(This Service Letter is F.A.A. Approved)

DATE: NOVEMBER 17, 1959
 SUBJECT: KIT - EMPENNAGE TO FUSELAGE ATTACHMENTS
 MODELS AFFECTED: M-20 AND M-20A SERIAL NOS. 1002 through 1540
 TIME OF COMPLIANCE:
 PARTS LIST: P/N 3471 Bracket (2)
 AN 4-23A Bolt (4)
 AN 174-13A Bolt (2)
 AN 365-428 Nut (6)
 AN 960-416 Washer (12)
 AN 960-416 L Washer (2)

INTRODUCTION

Figure 1

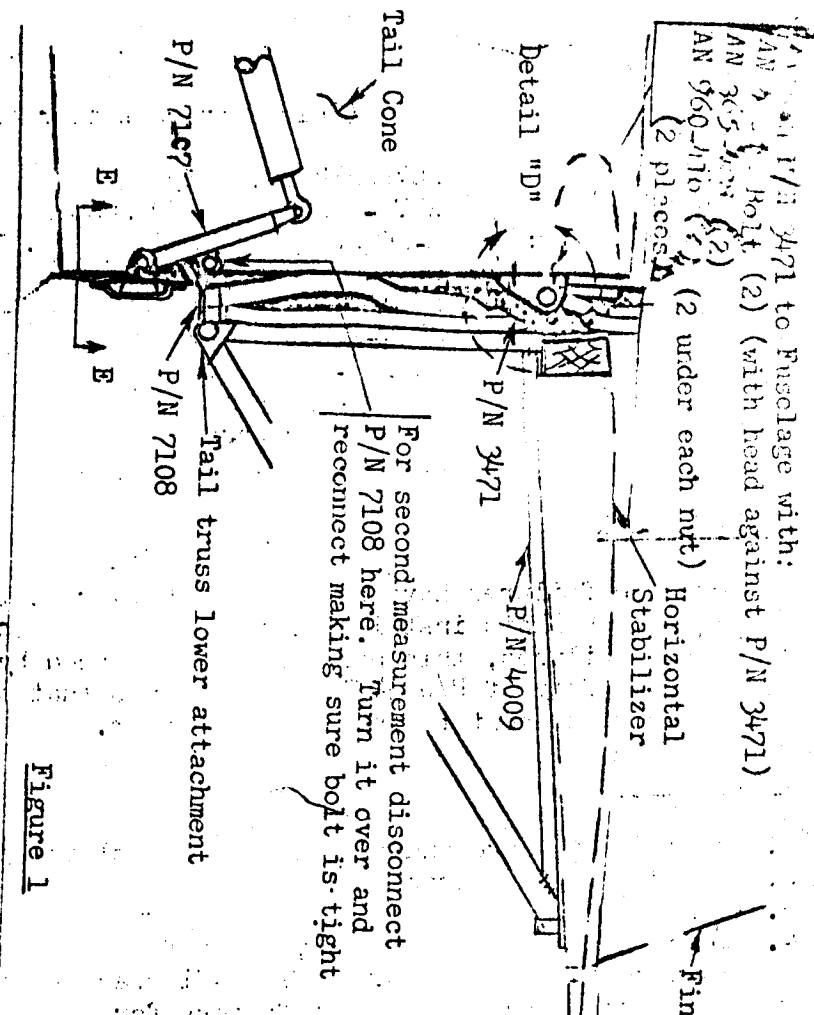
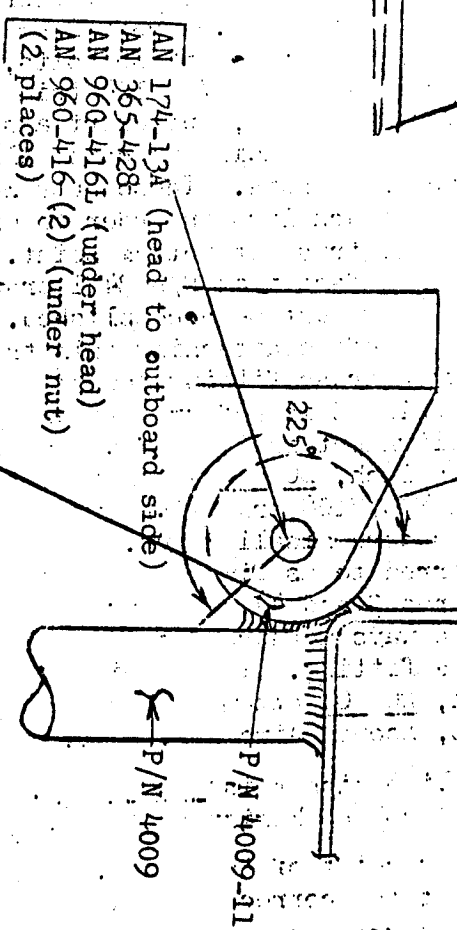
Although no failures have occurred on the present empennage to fuselage attachment (P/N 3009 with P/N 3449 Plate installed), tests indicate that, in order to eliminate the possibility of future failures, this part must be replaced by P/N 3471. These tests indicate that the margin of safety of P/N 3471 is many times that of P/N 3009. These replacement parts are furnished at no cost to the aircraft owner.

1. Remove empennage and side inspection plates just forward of rear bulkhead.
2. Remove P/N 3009 brackets.
3. Install P/N 3471 brackets. (See Figure 1)
4. Before replacing empennage, use a file to remove sharp edges of tail truss attach lugs where they bear against P/N 3471 brackets as shown in Figure 1, detail D. This item has been accomplished at factory for Serial No. 1448 and on.

5. Reinstall empennage. Install AN 174-13A upper attach bolts as shown in Figure 1. Before tightening nuts on these bolts, visually check alignment between the lower tail truss attach point and P/N 7108 trim link. If these parts are misaligned, do not attempt to fully align them, but exert a slight pressure at the lower tail truss attach point in a direction tending to cause alignment. Hold this pressure while tightening upper attach bolt nuts. These nuts must be tight so that brackets bear tightly against tail truss attach lugs in order to minimize empennage free play. See Item 6 before attaching tail truss at bottom point.

In this area
Chamfer outside edge both sides
of 4009-11. This chamfer should
be 45° x 1/64 Max.

Detail "D"

Figure 2
View A-E

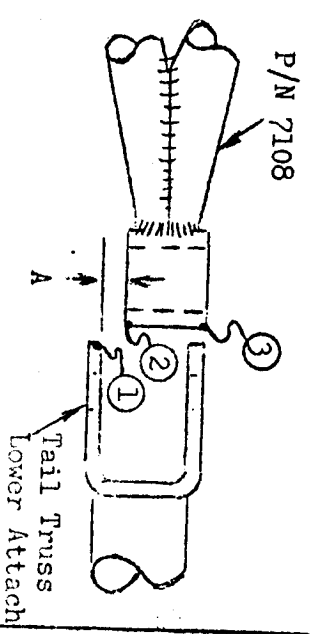
6. Due to the fact that P/N 3471 brackets are much stiffer than P/N 3009 brackets, the following must be accomplished. This must be done only after Item 5 has been completed. Before attaching tail truss at bottom point, measure and record misalignment between truss fitting and P/N 7108 trim link. This first measurement between Point 1 and Point 2 is referred to as Dimension A (See Figure 2). The maximum allowable misalignment is 1/32 of an inch. If the misalignment (Dimension A) is more than 1/32 of an inch, DO NOT attempt to mate parts at lower attachment, but do the following: Turn P/N 7108 trim link over at its point of attachment to P/N 7107 and again measure and record misalignment. This second measurement between Point 1 and Point 3 is referred to as Dimension B or C depending on the relationship between parts (See Figures 3 and 4). Be sure to make both measurements on the same side of the airplane and always measure from the outside of trim link to the inner edge (Point 1) of tail truss fitting. If the misalignment (Dimension B or C) is still more than 1/32 of an inch, DO NOT attempt to mate parts, but send a collect telegram to Spare Parts Department, Mooney Aircraft, Inc., Kerrville, Texas, with the following information:

First Measurement for misalignment of P/N 7108 & tail truss lower attach fitting.

Upon receipt of this wire, Mooney will ship by air a new P/N 7108 with the attach lug offset the correct amount to assure a proper fit. This part will be sent free of charge.

Figure 3
View B-E

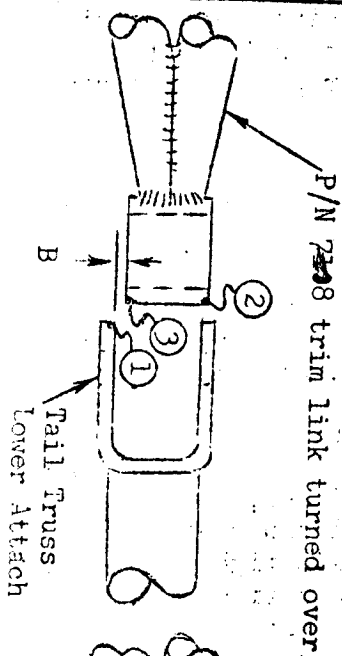
Second measurement for misalignment of P/N 7108 & tail truss lower attach fitting, made after P/N 7108 is turned. If relationship between parts is as shown in Figure 3 then second measurement is called Dimension B, and if as shown in Figure 4 measurement is called Dimension C.
